RE: Docket No. 466: Frost Bridge to Campville 115-kV Project
Development & Management Plan Change Notice Request:
Structure 3236: Proposed 75-foot In-Line Location Shift, Town of Litchfield

Frost Bridge to Campville 115-kV Project Development & Management Plan

Litchfield/Harwinton, CT | Map Sheet 31 of 35

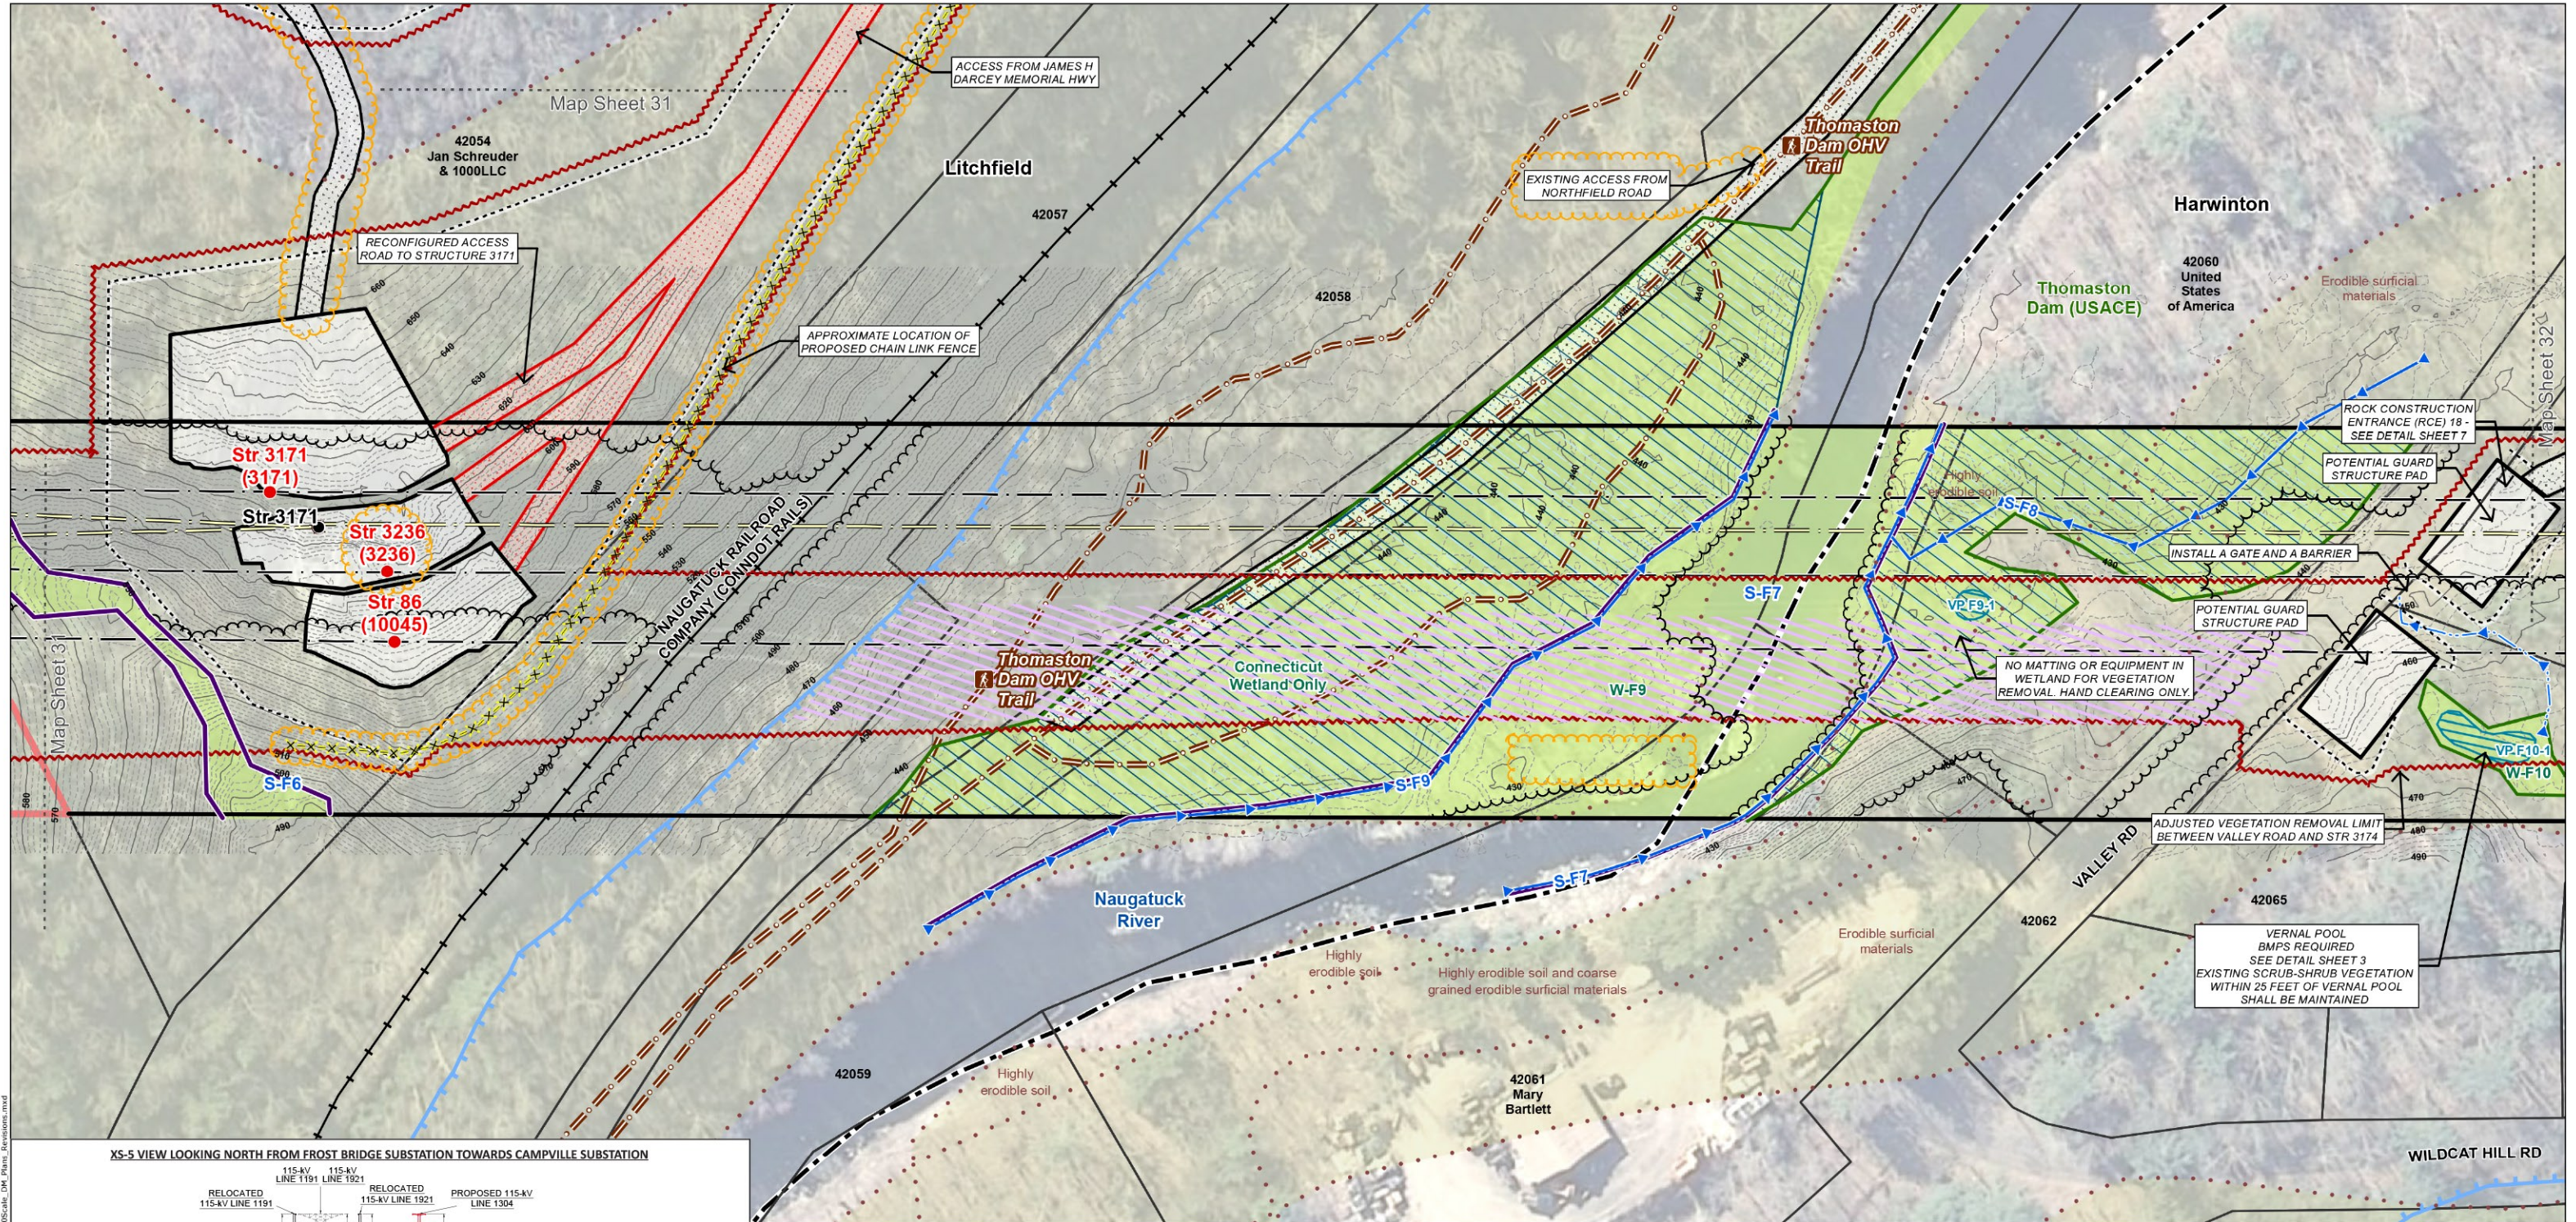
To facilitate construction during the Project's approved outage sequence, Eversource proposes to shift the location of Structure 3236, the new monopole required for the 1921 Line circuit separation on the south side of the Naugatuck River crossing. Eversource proposes to shift the location of this new structure 75 feet to the north (refer to the attached Development and Management Plan Mapsheet 31 [rev 2], Line List 42054, Town of Litchfield). The revised Structure 3236 location will remain within the portion of the work pad that is already constructed in this upland area, which is characterized by shallow depths to bedrock and challenging terrain.

The proposed shift in the location of Structure 3236 is required to facilitate the completion of work on the 1921 Line within the Project's approved outage sequence, which was recently compressed in comparison to the original sequence. This shift in the location of Structure 3236 will allow Eversource's construction contractor to complete critical pre-outage work within the limited timeframe between the scheduled outages on the 1921 Line.

If Structure 3236 is not shifted to the north as proposed, work on the installation of this structure cannot begin until the existing steel lattice tower (Structure 3171) that previously supported both the 1921 Line and the 1191 Line is demolished. At the current location, only after the tower is removed would the contractor have the necessary access to build out the southern portion of the work pad for Structure 3236 and commence work on the Structure. Given the recent compression of the outage sequence, there would be insufficient time to complete the critical pre-outage work.

The proposed shift of Structure 3236 eliminates both the need to demolish the existing steel lattice tower at this time and to build-out the southern portion of the work pad, thereby allowing the critical pre-outage work to commence expeditiously and in accordance with the approved outage sequence.

Eversource has determined that the minor structure location shift will have no effect on the Naugatuck River span or on other engineering factors regarding the 1921 Line. Furthermore, the proposed structure shift will not affect any environmental resources, is located on the same property within the same work pad, and is in an undeveloped area with no proximate residential development.

NO.	DATE	REVISIONS	BY	CHK	APP	APP
REV 2	4/5/2017	MOVED STR 3236 75 FEET TO THE NORTH	NC	MD		
REV 1	1/24/2017	ADDED EXISTING ACCESS FOR TEMPORARY CONSTRUCTION ACCESS TO STR 3171. ADDED PROPOSED CHAIN LINK FENCE. ADDED EXISTING ACCESS ROAD CALLOUT AND REMOVED WETLAND WORK RESTRICTION NOTE	NC	MD
